Work Order ID 55842

Item Name: Rib

DRAWING NO. D3265	TITLE BASKET BASE ASSEMBLY (350)	REV. C	DART AEROSPACE LTD ENGINEERING ORDER		D.E.O. NO. D3265-C-1	SHEET NO. SHEET 1 OF 2	SCALE NTS
DRAWN <i>PH</i>	CHECKED <i>PH</i>	MFG. APPR. <i>DD</i>	APPROVED <i>MD</i>		DE APPR. <i>MD</i>		
DATE 09.04.16	DATE 09.04.16	DATE 09.04.16	DATE 09.04.16		DATE 09.04.16

SHEET 3, MODIFY SECTION A-A AS SHOWN:

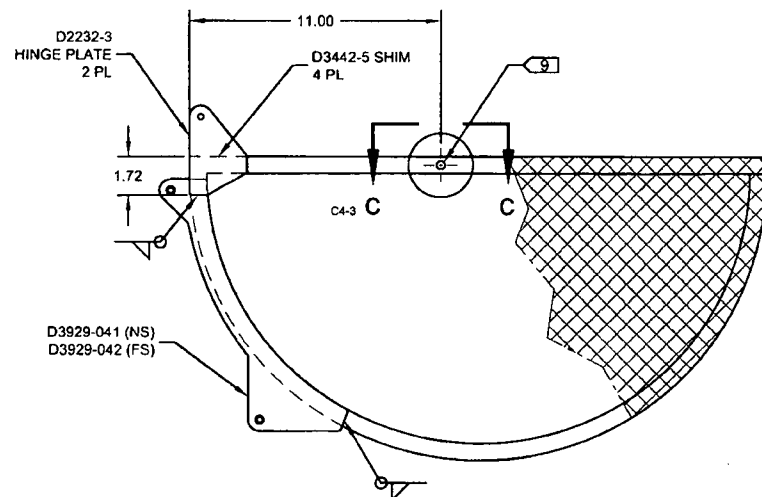
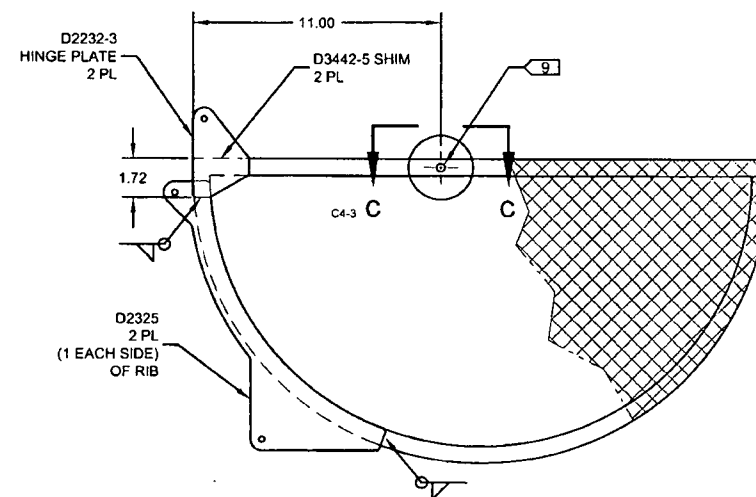
IS:

SECTION A-A AS-2
2 PL
(BOTH END RIBS)

WAS:

SECTION A-A AS-2
2 PL
(BOTH END RIBS)
